**DER Technical Forum – Record of Issues Raised & Resolved**

# Reactive Capability Simulation studies Type C & D

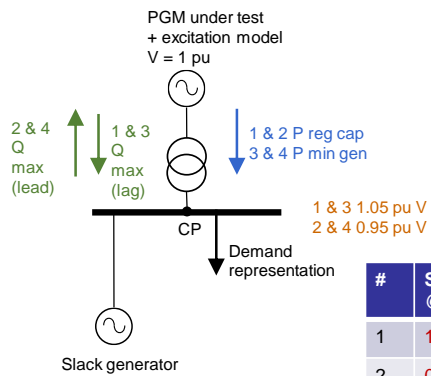
4	Andy Hood	06/01/19	WPD	How should Reactive Capability be simulated? Is it practical for Type C / D studies to be based on a 1.0pu voltage on the generator terminals and 1.05 and 0.95 pu voltage at the Connection Point and 0.95 lag and lead power factors? Should the source impedance be modelled etc.?	Answered	N/A	This question was answered in appendix 1. Refer to Annex C.7.3.3.	12/02/19
5	Luis Mayor	06/01/19	PSE2 Consulting	A question on the aggregation, or otherwise, of SPGMs.	Answered	N/A	It has been confirmed on many occasions that SPGMs which operate independently are not aggregated.	12/02/18
6	Chris Marsland	06/01/19	AMPS	What paperwork will DNOs accept to demonstrate compliance	Answered	N/A	DNOs continue to accept manufacturers' self-certification of compliance, although the ENA does review all manufacturers' type testing information before it is published on the ENA's type test register.	19/12/18

### Case 1

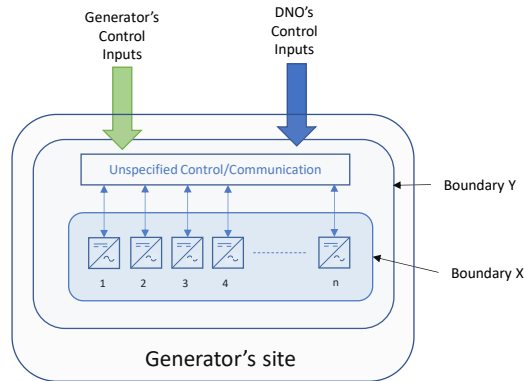
**Boundary X**  
G99 Compliance can be demonstrated by manufacturers (in the factory) for a single Unit or a Module composed of n Units.

May or **may not** be compliant on site dependent on disposition and behaviour of communication and control equipment on site.

**Boundary Y**  
G99 Compliance can be demonstrated by Generator on site with actual specific control/communication equipment included.

Can be demonstrated by manufacturers (in the factory) for a single Unit or a Module composed of n Units either where the manufacturer provides the control equipment, or where a clear specification for the control/comms equipment exists.

### Case 2

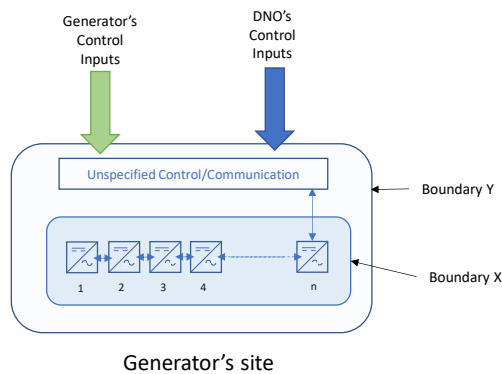
**Boundary X**  
G99 Compliance can be demonstrated by manufacturers (in the factory) for a single Unit or a Module composed of n Units. Also needs to demonstrate the response meets the timing requirements of G99.

Can also be demonstrated on site.

**Boundary Y**  
Not relevant for compliance with RfG and G99

Relevant for compliance with any DNO site-specific requirement, but to be defined on a site by site basis

## Reactive Power Capability – Case Study

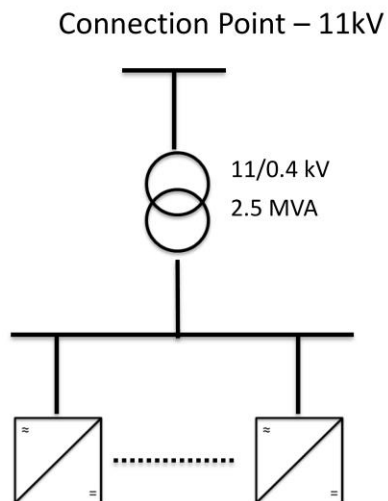
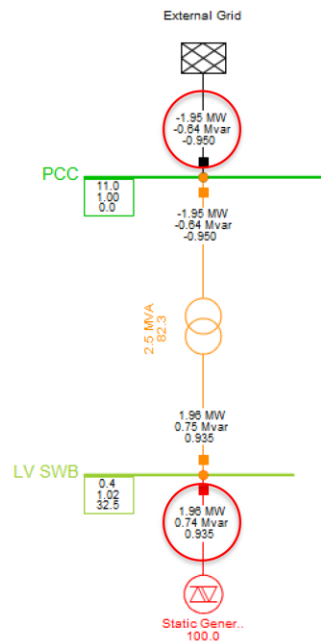
Is the plant compliant with EREC G99 Power Factor Requirements?
